QUALITY ASSURANCE -- NON-CONFORMANCE REPORT

Location: Changxing Island, Shanghai, PRC **Report No:** NCR-000191
Prime Contractor: American Bridge/Fluor Enterprises, a JV **Date:** 04-Sep-2008
Submitting Contractor: Zhenhua Port Machinery Company, Ltd (ZPMC), Changxing Island **NCR #:** ZPMC-0172

Job Name: SAS Superstructure

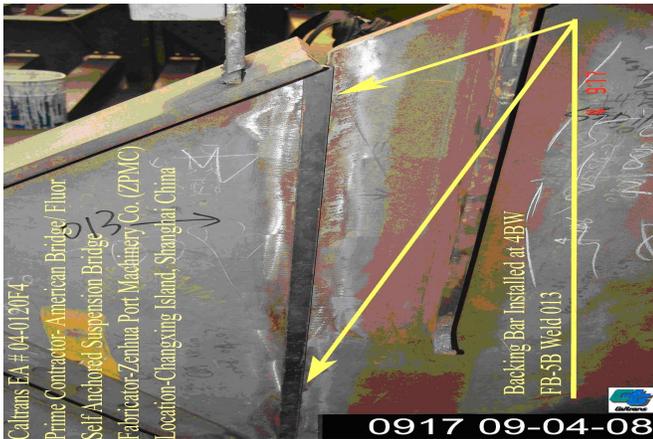
The Contractor's QC allowed welds that do not conform to detail drawings to be performed in fabrication. The Contractor installed backing bars at locations where backing bars have not been specified. This was observed in weld joints 4BW-SSD11-PP027-013 of OBG segment SEG 4BW and 3AW-SSD12-PP022-133 of OBG SEG3AW.

ZPMC installed back-up bars per WPS BT2213-B-U2-F-1 because the root gap was in excess of that allowed for the approved WPS for that joint type. Once the weld was completed with the back-up bar in place, the back-up bars were then removed, the weld back gouged on the back-up bar removal side and finished welded. The weld then received the required Visual and NDT inspection.

The backing bar was removed. The current weld condition conforms to the detail drawing.
